Agenda Item	6.3
Report No	PLS-09-25

Report Title: 24/00531/FUL: Mrs Ann-Marie MacRae
Land 40M East of Moidart, Badabrie, Banavie, Fort William

Report By: Area Planning Manager – South

Description: Erection of house and detached garage, driveway, drainage scheme, package treatment plant and soakaway

Initial 03

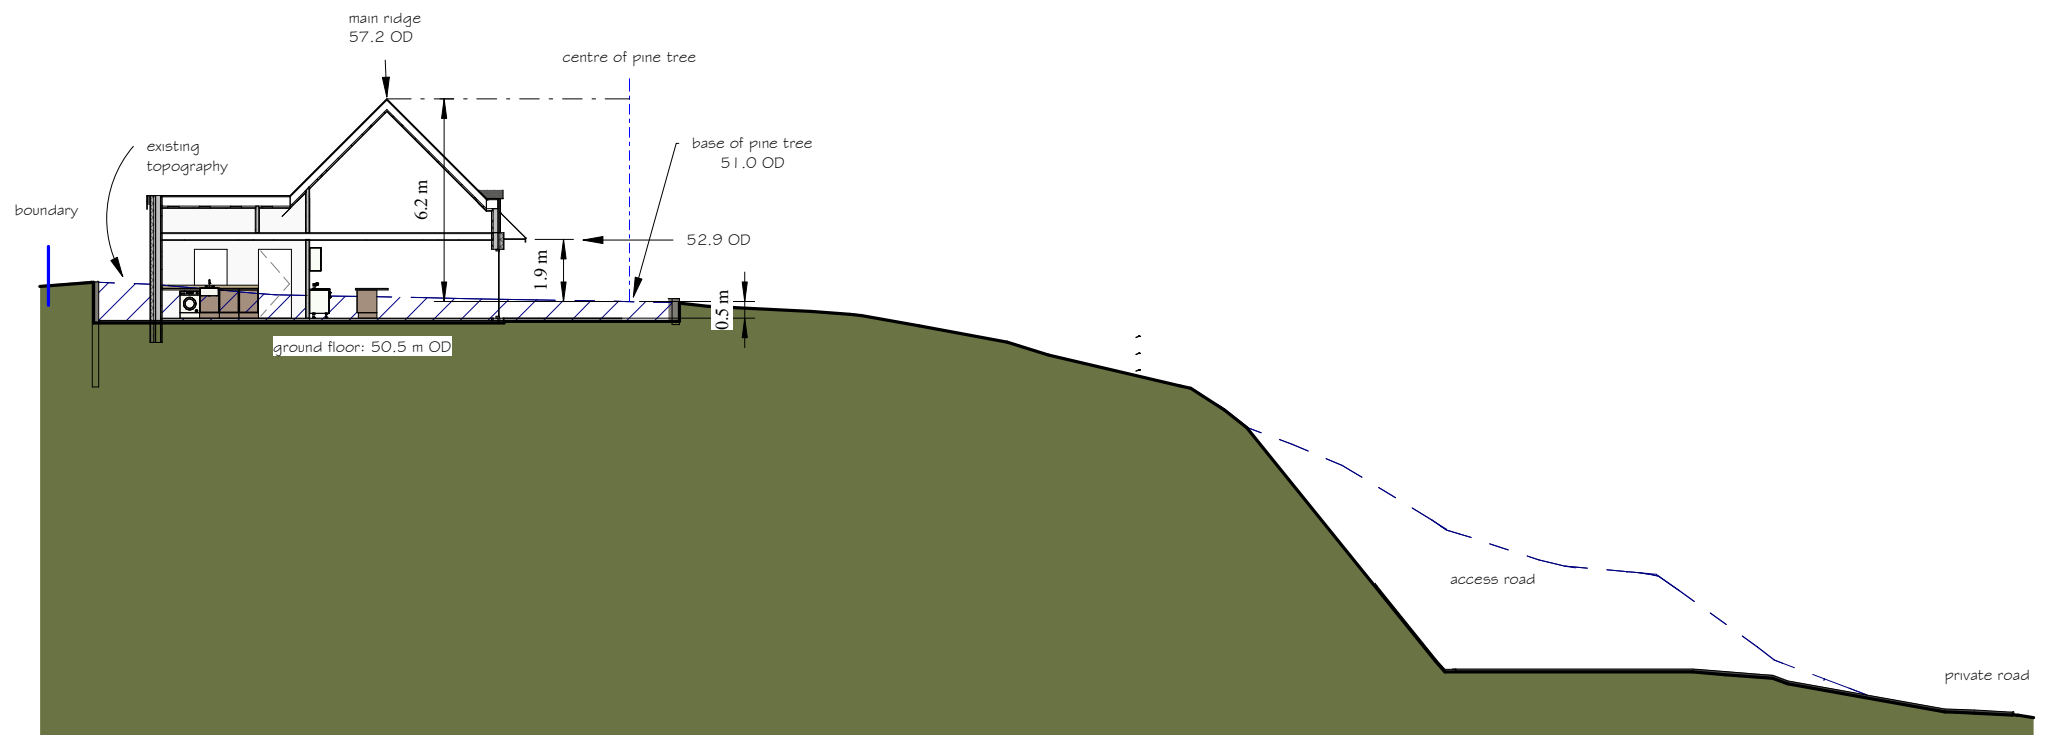
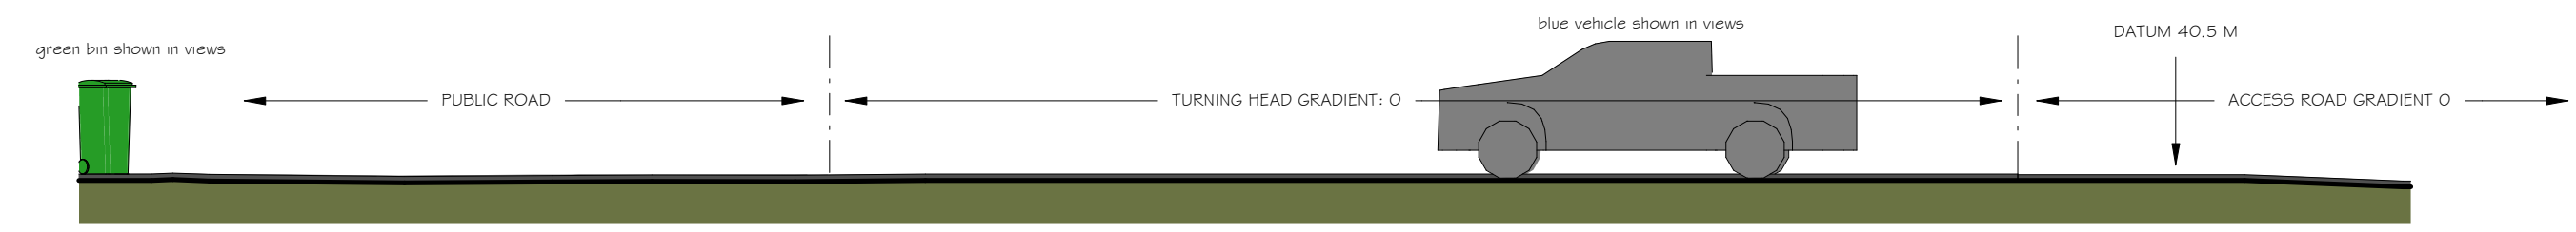
04.12.24 in response to further Tree Survey: **Objection** – The red line of the application (Location Plan 03 submitted 09.10.24) extends east out of the settlement development area and beyond the TPO, and into an area marked as Green Network on the Fort William West Plan.

- 8.27 An amended plan was submitted 2.10.24 which showed the turning head enlarged to 5 x 15m to bring the geometry of the turning head up to standard and enable the bin lorry to turn. This change was welcome in principle however no swept path analysis was provided to demonstrate its adequacy. The bins and the grit bin were to be re-located to the west side of the turning head, and a streetlight would need to be re-located. However, in further correspondence from Atholl Associates (11 Nov 2024) and from the applicant (12 Nov 2024) they have rolled back from this proposal, as the bin lorry was apparently observed turning here and therefore, they do not consider the enlargement of the turning head to be necessary. A further amended site location/layout plan was submitted on 09 October 2024, and this keeps the turning head as existing. This drawing matches the drawings in the Drainage Impact Assessment by Atholl Associates.

Turning head and access road gradient
1 : 100

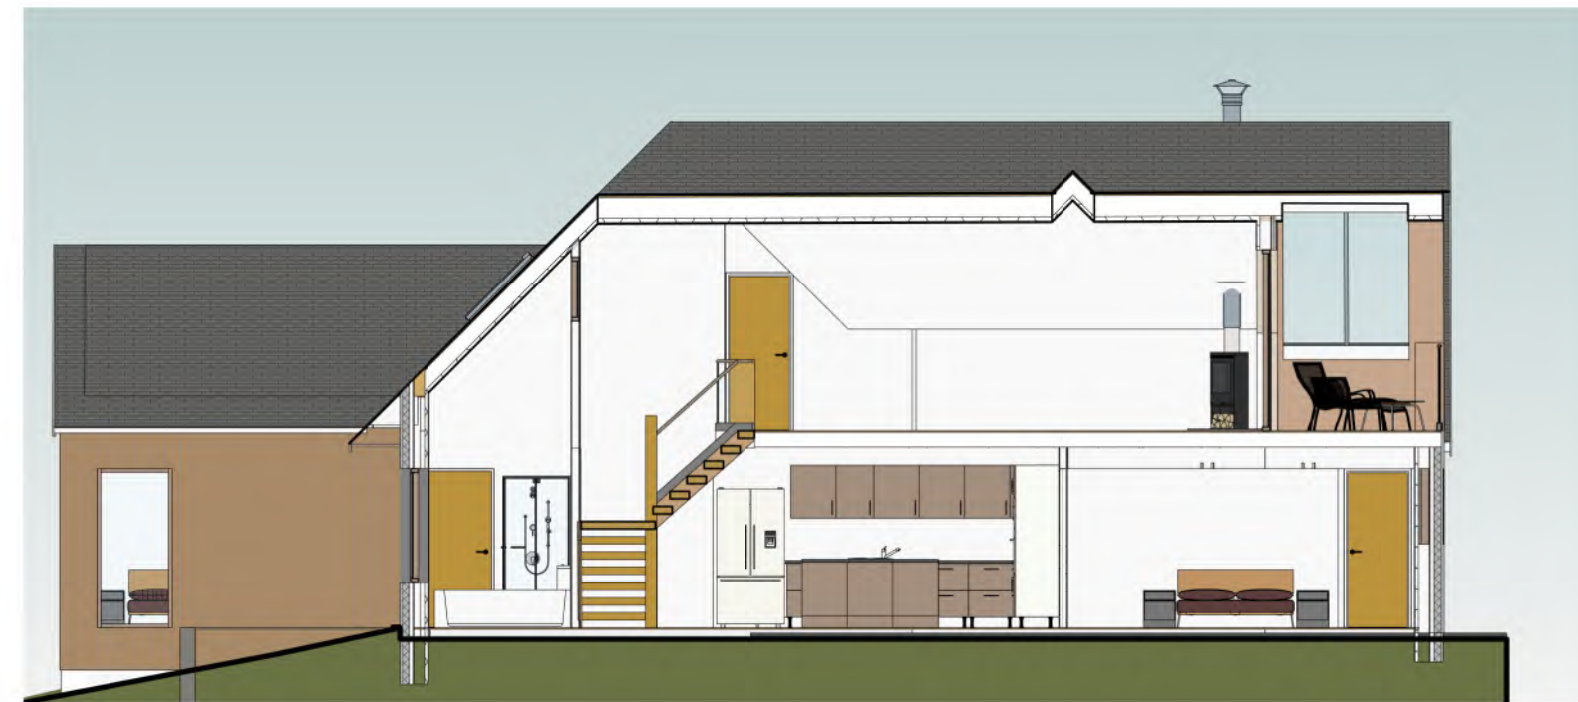
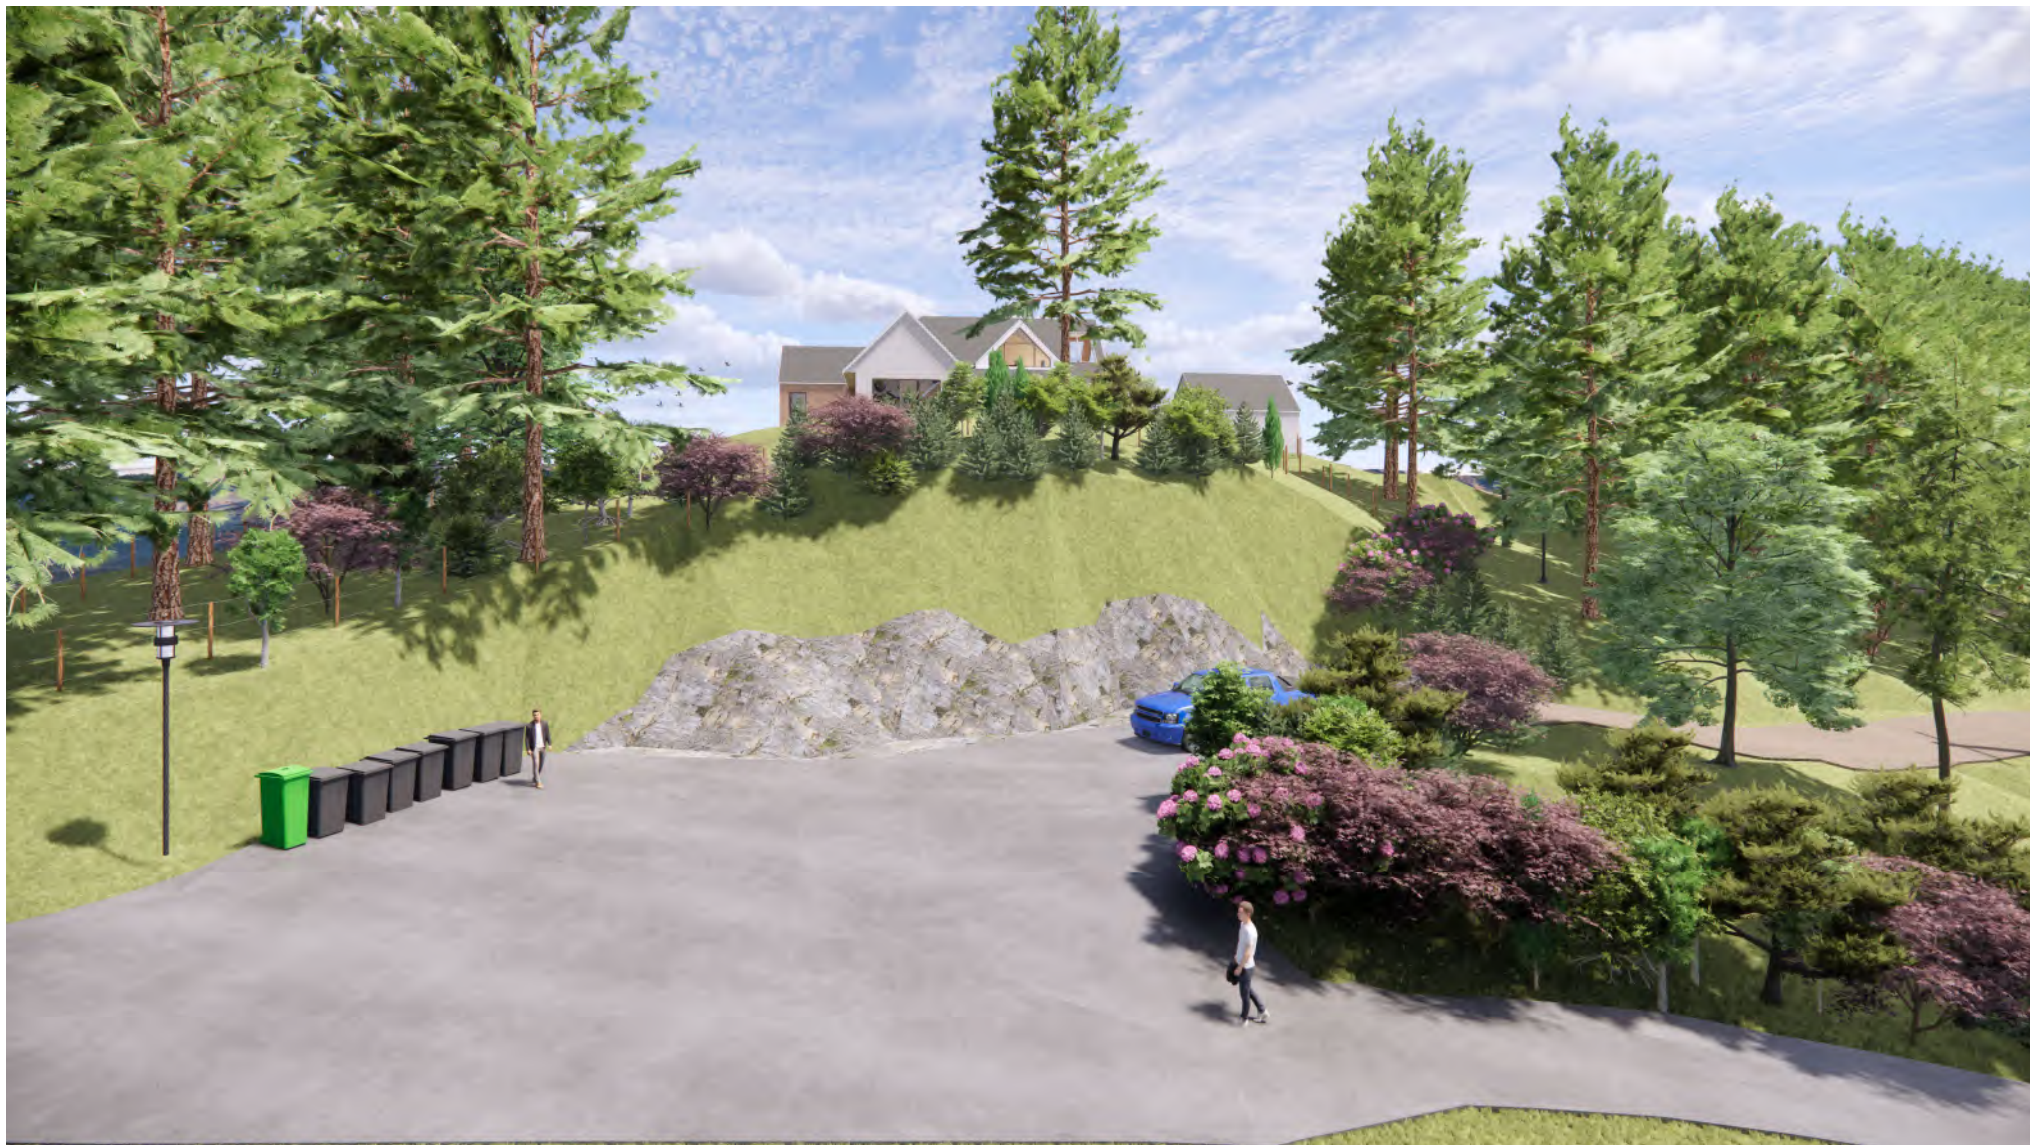
The View 3 drawing showing the turning head appears to meet the requirements of a residential turning head, and space for bins and the grit bin. There is no information showing the relocation of the lighting column, however this could be dealt with by condition.

The amended turning head would require the refuse vehicle to use part of the private access track to manoeuvre and it would require a 4 or 5 point turn involving a significant vehicle overhang into the property to the south and potentially conflicting with the bin area. The enlarged turning head does not therefore provide any significant improvement over the existing arrangement.

Tree Protection Plan

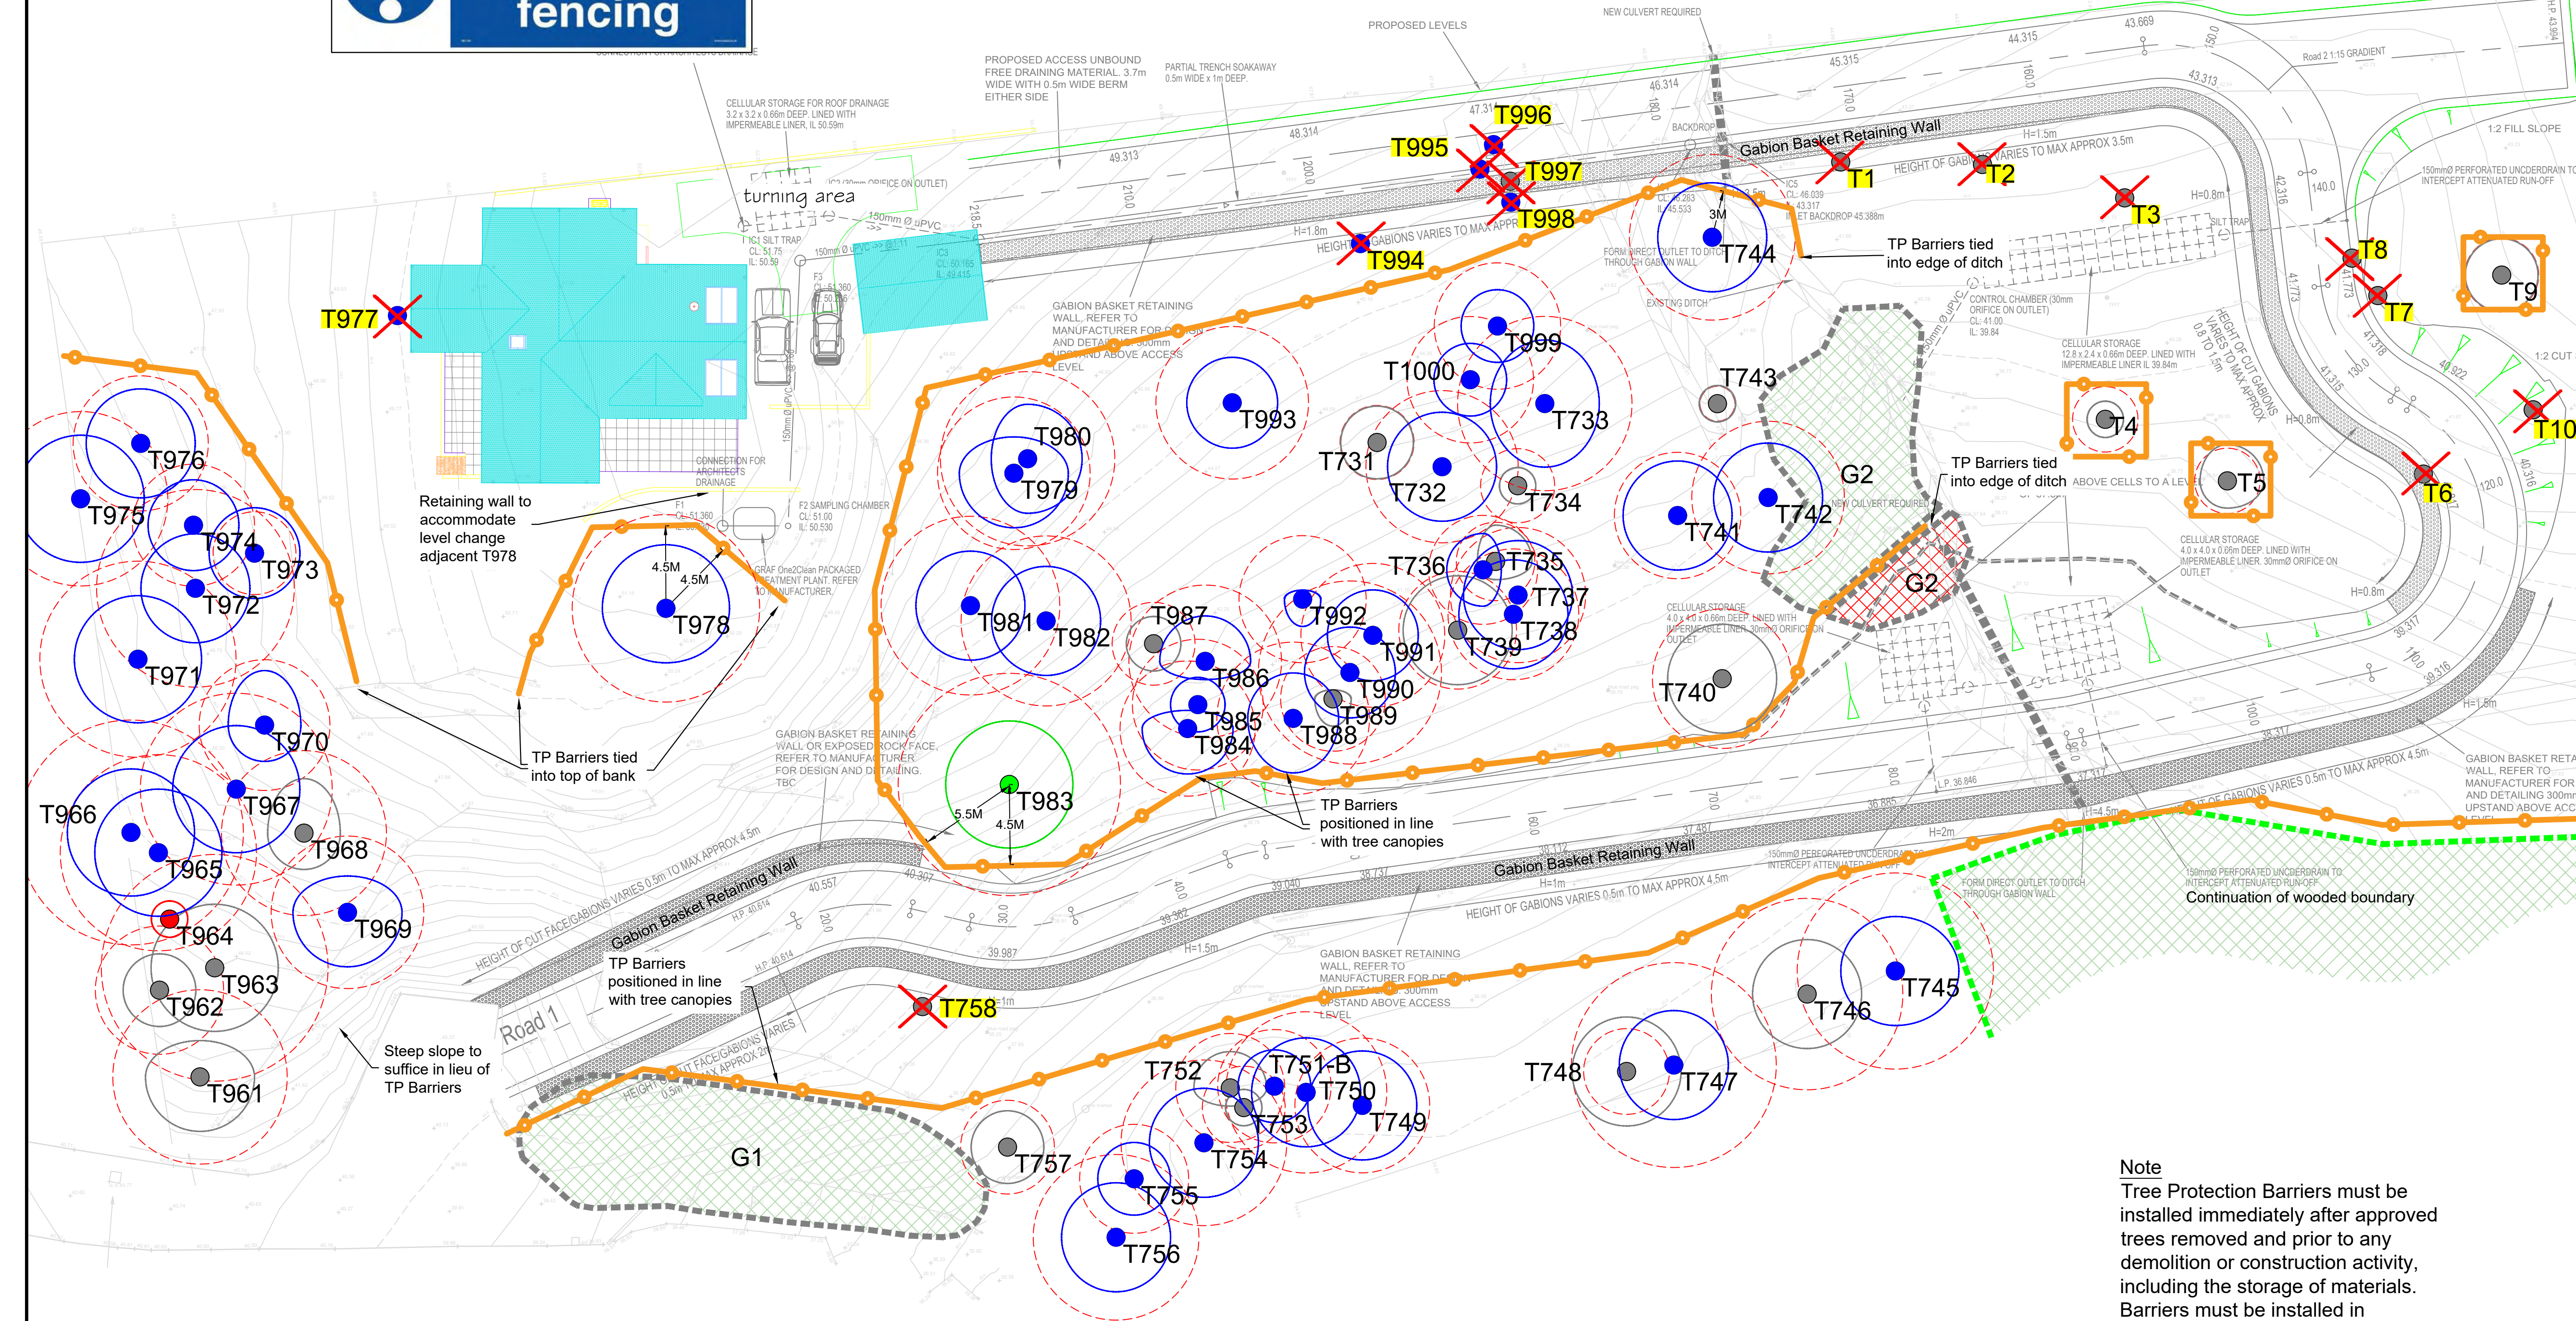
Also, the proposed location of the foul drainage treatment plant is on shallow soil (up to 0.3m deep) and rock. The treatment plan proposed would be a min 2m high, and therefore would require excavation that would be likely to impact on the RPAs of trees T978 and T981 [or T983 – a category A quality tree].

The direct impact on trees is now greater than was presented in the previous Tree Plan (June 2024) – to which we also objected. No replacement planting proposals are submitted.

- 8.15 A further 5 trees' Root Protection Areas (RPAs) would be eroded, as identified in the Tree report (AIA), and there are concerns that a further 3 would be similarly affected due to the proximity of excavations and due to the siting of the foul drainage treatment plant. Total tree loss would be at least 14 individual trees plus part of tree groups G1 and G2, and a further 5-8 likely to be damaged by incursions to the RPAs out of 67 on the site – a significant proportion of the woodland. Five of the 14 individual trees that would be lost are category B, the remainder being category C, and 4 out of the 5 trees that would have RPAs affected are category B, and 1 is category A. This is a relatively young group of Scots Pine – 30-40 years old, and the C categorisation largely reflects their modest stature rather than being poor in terms of their health or condition.
